Subject: Fuel Leak Case No. RO0002908 and Geotracker Global ID T0600196622, Miller Square Park,
2259 First Street, Livermore, CA 94550

Alameda County Environmental Health (ACEH) staff has reviewed the fuel leak case file for the above referenced site including the recently submitted document entitled, "*Revised Work Plan*," dated September 28, 2009, which was prepared on behalf of Chevron by Conestoga-Rovers & Associates. In correspondence dated August 4, 2009, ACEH requested that you address our technical comments on a June 10, 2009 document entitled, "*Pilot Test Work Plan or Draft Corrective Action Plan*."

August 4, 2009

Alameda County Environmental Health (ACEH) staff has reviewed the fuel leak case file for the above referenced site including the recently submitted document entitled, "*Pilot Test Work Plan or Draft Corrective Action Plan*," dated June 10, 2009, which was prepared on behalf of Chevron by Conestoga-Rovers & Associates. Although the document is entitled, "*Pilot Test Work Plan or Draft Corrective Action Plan*," the document does not propose a pilot test or corrective action. Instead, the document is a work plan to install four monitoring wells for the purpose

Site: FMR. TEXACO 30-7233
Sounding: CPT-01

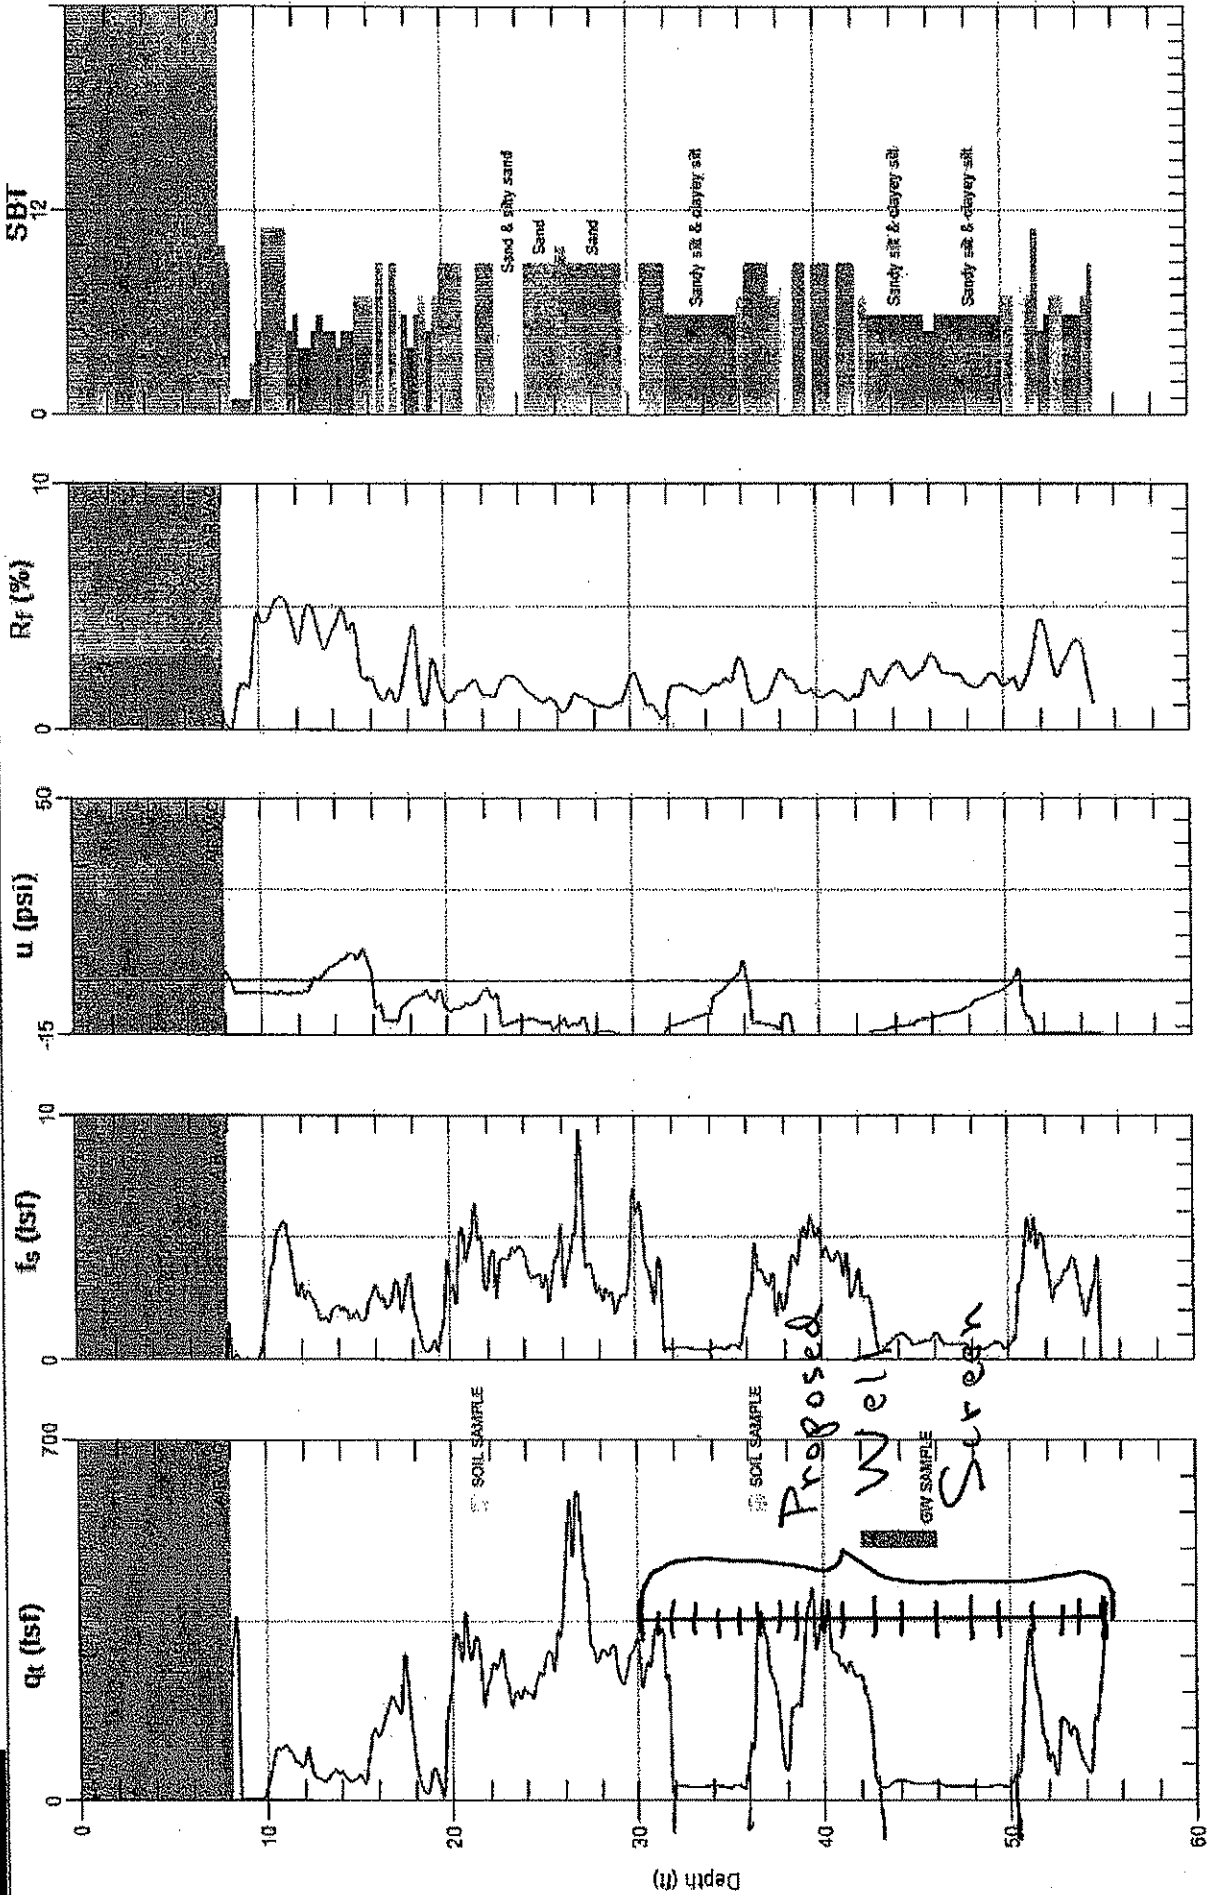
- 2. Proposed Well Screen Intervals.** The proposed screen intervals for the four monitoring wells are 30 to 55 feet bgs based on previous depth to first encountered water and variable groundwater elevations at nearby sites. Site hydrogeologic conditions than variable depths to first encountered groundwater must be considered in designing well screen intervals. The well screen intervals must target discrete water bearing layers and not create vertical conduits for ambient well flow. Where necessary, multiple wells must be installed to monitor separate vertical intervals. Since the proposed well locations are adjacent to previous soil borings, the hydrogeologic conditions at the proposed locations are known and must be considered. As one example, we have attached the CPT log for boring CPT-1, which is adjacent to one of the proposed well locations. As shown on Attachment 1, the proposed well screen interval from 30 to 55 feet bgs connects three separate coarse-grained layers that are separated by finer grained layers. A well constructed in this manner at the proposed location would provide a conduit for vertical flow and water levels in the well would be affected by vertical gradients between the difference intervals. Clearly, the proposed well screen interval for a well adjacent to CPT-1 would not be appropriate. A second example of the need to consider the site hydrogeology is shown on Attachment 2, which is the CPT log for boring CPT-5. The proposed well adjacent to CPT-5 would be screened exclusively in the finer-grained soils consisting of silts and clays present between approximately 11 and 55 feet bgs. The proposed well screen would not intersect any permeable water-bearing layers. Therefore, the proposed well at this location would not provide sufficient data on contaminant migration off-site since the well does not intersect the likely pathway for contaminant migration. Please review site hydrogeology and propose screen intervals that are appropriate for the site.
